REMARKS

As restricted, the presently claimed invention relates to surgical instruments for distracting an intervertebral space, and in some claims also guiding an implant into that space.

FIG. 1

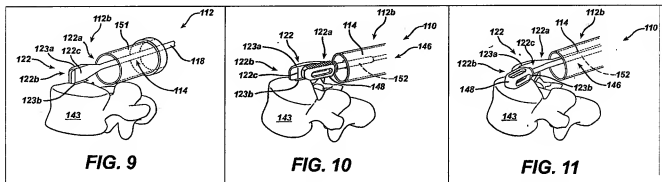
Independent claim 1 recites a distractor, with a shaft and a distal paddle, and a filler bar that is shaped to removably engage the shaft and paddle to provide torque strength so that the distractor can be inserted between adjacent vertebrae and rotate to distract the vertebrae. Dorchak does not have such a filler bar. Dorchak has two distractors, each with a shaft, and each abutting the other, that are driven in laterally with a hammer to distract the vertebrae.

The Examiner asserts that one of the two shafts of Dorchak (shaft 41b) is the filler bar. But even if this shaft could be said to releasably engage the paddle and shaft of a distractor (it engages distractor 12b and abuts shaft 41a), it does not engage these two elements so as to provide torque strength for rotating the tool to distract. When shaft 41b is threaded into distractor 12b, the two distractors are placed in an abutting relationship and hammered in to distract. They cannot be rotated as they merely abut each other – one cannot provide torque strength for the other because they merely abut, a person of ordinary skill could not rotate the distractor assembly of Dorchak – only its separate parts. Even there, there would be some concern that rotating would disengage the screw threads.

An important tool in this system is the distractor assembly 10 illustrated in Figure 1, for example. The assembly 10 includes a distractor 12 and a filler bar 26. The distractor has a handle 16 on its proximal end, a distracting paddle 22 on its distal end, and a shaft 14 in between. The filler bar 26 mates with features on the distractor to provide rigidity and torque strength so that the distractor can be inserted between vertebrae 41,4 with the paddle horizontal, and then rotated approximately 90 degrees to distract the vertebrae using superior and inferior surfaces 22c, 22d of the paddle.

Following distraction, the filler bar 26 can be removed from the distractor 12 to increase the amount of space available, as well as to increase the surgeon's visibility (the distractor 12 with the filler bar 26 removed is illustrated in Figure 2). In addition, an implant inserter can mate to the distractor using the same features that the now removed filler bar had mated to.

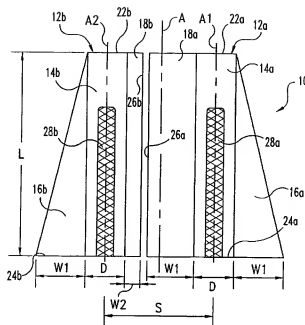
The drawings are objected to under 37 CFR 1.83(a). The drawings must show every feature of the invention specified in the claims. Therefore, the "angled guide feature" must be shown or the feature(s) canceled from the claim(s). No new matter should be entered.

Regarding the "angled guide feature," Applicant notes that this feature is shown at least in Figures 9 to 11 (and provided and discussed below) which illustrates "one embodiment of a distractor 112 that includes a paddle 122 having an angled distal end 122 b, and thus providing an angled guide surface 122 c" - this angled guide surface having an angled distal end is a preferred

embodiment of the "angled guide feature" as claimed (see claim 11, for example). Accordingly, the "angled guide feature" is illustrated in the drawings at least to the extent that the called out "angled guide surface" is a preferred embodiment of that feature.

FIGS. 9 to 11 illustrate one embodiment of a distractor 112 that includes a paddle 122 having an angled distal end 122b, and thus providing an angled guide surface 122c. Many times,
